বিষয় : রোড সেফটি অডিট রিপোর্ট অনুযায়ী প্রয়োজনীয় ব্যবস্থা গ্রহণ প্রসঙ্গে।

Road Safety Audit Report

Road Name: Bhanga-Bhatiapara-Mollahhat-
Fakirhat- Noapara National Highway (N805)
Audited Length: 111 Km

Road Safety Audit Report

Figure 01c: Typical Design for T-Junction (With Merging Lane)

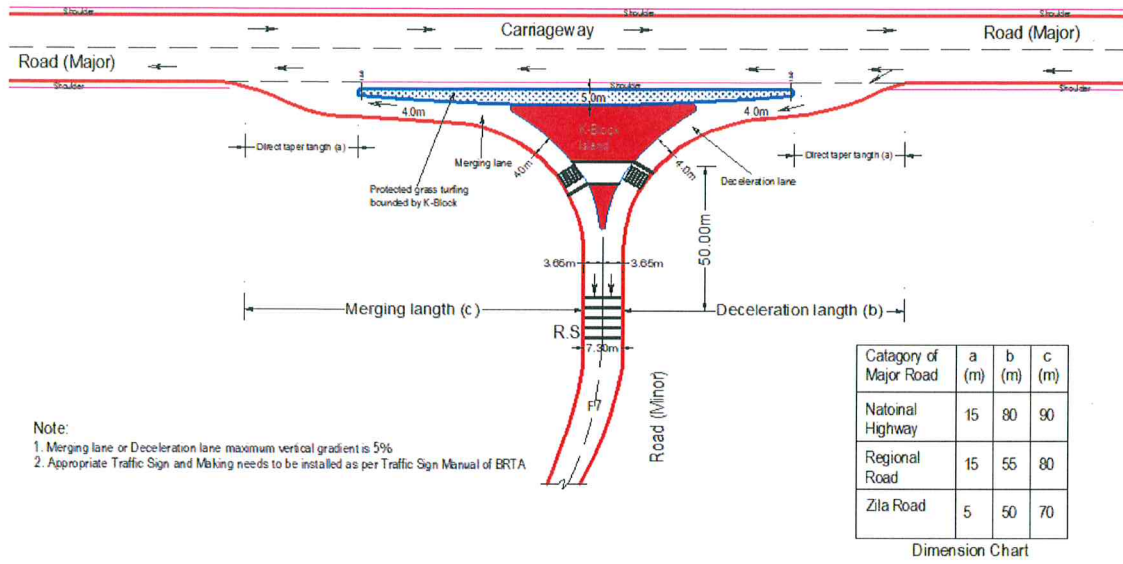
Problem: Most of the side road either connecting in Y shape or T, are found to be risky due to poor layout and visibility. They are too steep and sometimes the risk would be too high when their visibility is severely hampered due to road side trees, unauthorized billboard etc.

Recommendation: Minor roads (Side roads) should be connected to Major Road in such a way that the 3-wheeler non-motorized vehicle cannot enter directly to the Highway. Moving vehicle from side road needs to enter in main Highway through merging lane. RHD minor road and other (e.g LGED, Pouroshova etc) roads should not directly connect to the highway, rather it should follow the typical design given below. More importantly, road side trees, unauthorized billboard etc., needs to be removed to improve the visibility of the driver. It should be noted that as Y and X type junctions are more dangerous, the layout should be re-aligned in such a way that it turns to T and + type at junction.

Figure 04d: Typical Safety Measures at Bridge Railing End

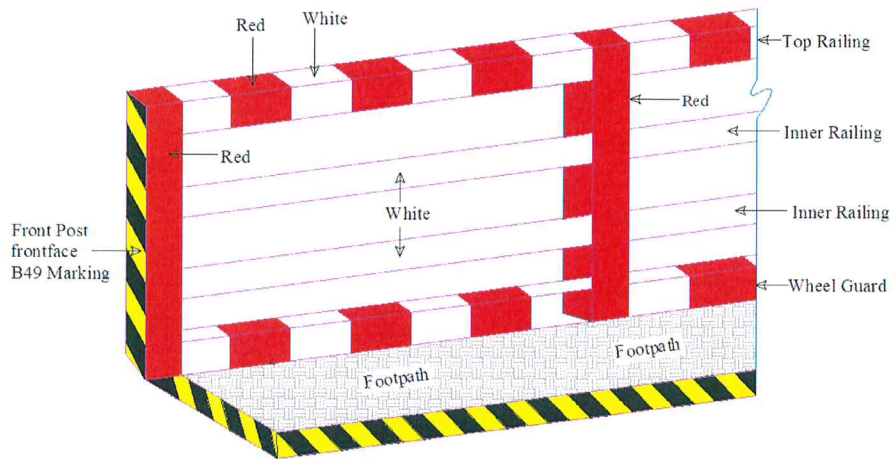
Problem: Almost all bridges on this Highway is found without any types of Road Marking. Some bridges seem freshly painted but none of them are reflective. Some of the bridge approaches are without proper delineation/ guide post and other safety barriers. At the chainage of 101+ 500 two consecutive bridges were found to be more hazourdous due to lack of proper safety measures.

Recommendation: Bridge approaches should have adequate safety measures though installation of guide post and/or crush barrier, especially in high embankment. Moreover, the entry post of the bridge railing should have appropriate hazard marking to improve conspicuity of railing at night. *No Overtaking Sign* along with marking is mandatory of such bridges and approaches.

Figure 05b: Typical Design for Speed Table and Thermoplastic Rumble strips

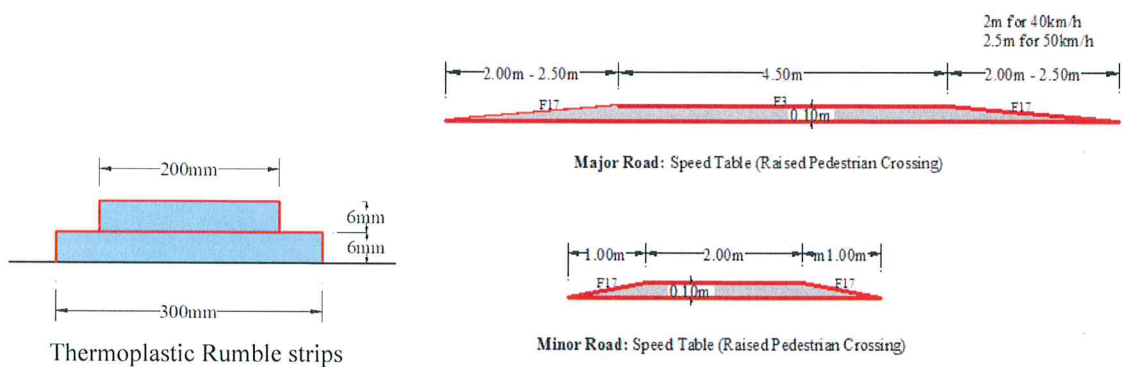
Problem: Numerous speed breakers are found in different locations throughout the N805 which are unspecified and are creating stress to the drivers.

Recommendation: Any unauthorized speed breaker should be dismantled. Speed hump or table can be installed, depending on speed limit. Speed table can be installed with raised pedestrian crossing (if pedestrian crossing needed) with sets of rumble strips ahead of such speed reducer with appropriate traffic sign and marking.

Figure 06d: Typical Road Section with proper Sign

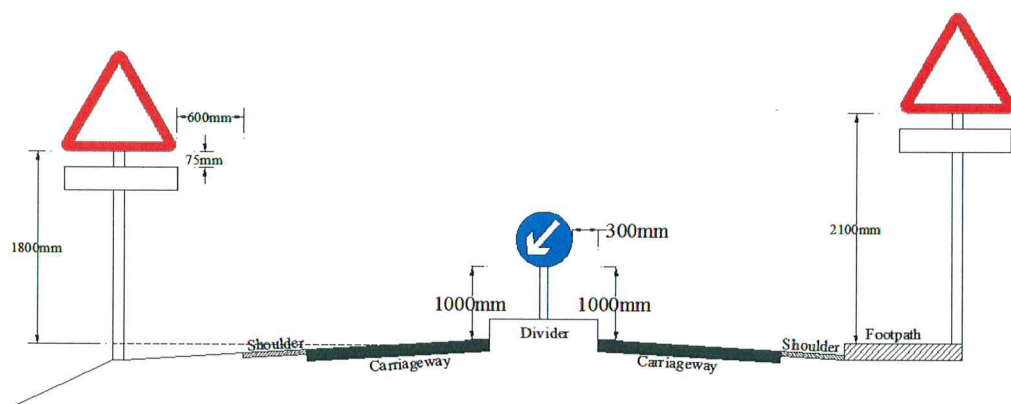
Problem: At some chainage the road Markings and traffic signs are found to be unspecified in their dimensions and at some chainage they are found to be incorrect. Adequate *chevron sign* is not given on sharp bend. *No Overtaking Sign* is used in the road, but a *Broken White Center Line* is given instead of *Continuous White Line* which is improper and dangerous. Some identical unspecified speed limit is provided but speed restriction end signs are totally absent. Shoulder and the carriage way are not at the same level which makes the road more susceptible to road crush.

Recommendation: Road sign size shape and placing should conform the traffic sign manual. To fix the speed limit of any road segment, it should be appropriate as per traffic sign manual, shown in Paragraph E2.3. After imposing appropriate speed limit of any area, speed restriction end sign also needs to be placed at the end. To have better visibility at night, Signs should be retroreflective, therefore it should be diamond grade as per traffic sign manual. Road marking, particularly at sharp bend, it should have continuous center line with chevron marking on the outer side of the road at certain intervals. Any obstructed vegetation needs to be cleared at inner side of the curve. Shoulder drop is dangerous and therefore needs to be same level with the main carriageway.

Figure 09b: Typical design of well Treated Nose

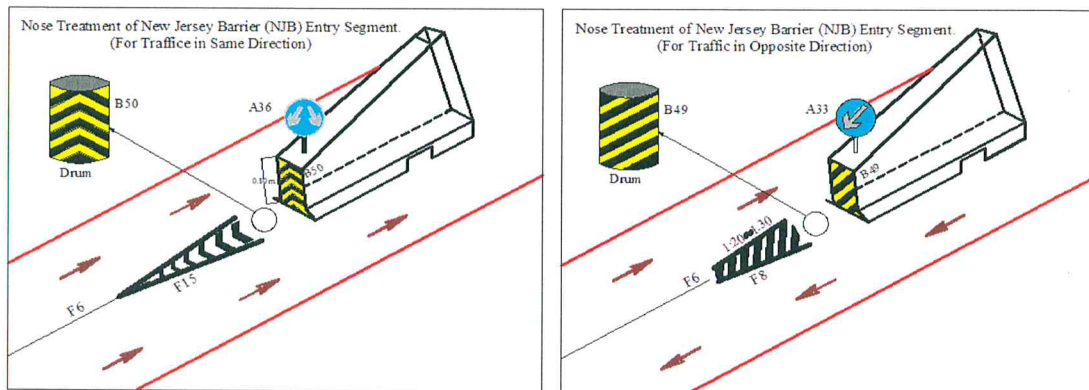
Problem: Almost every nose of road divider is quite tough to get noticeable to the driver. The absence of delineator, road marking with reflective paint is almost common scenario at various divider noses, which had been damaged due to vehicle collision, as perceived.

Recommendation: Proper end protection of concrete median is needed to protect the barrier from impact. Moreover it is very important to aware the drivers of such hazard well ahead by providing appropriate Traffic Sign and Rumble Strips. By providing the appropriate *Hazard Marking* with Sand Cushion Drum is also needed to protect the Nose of such medians.
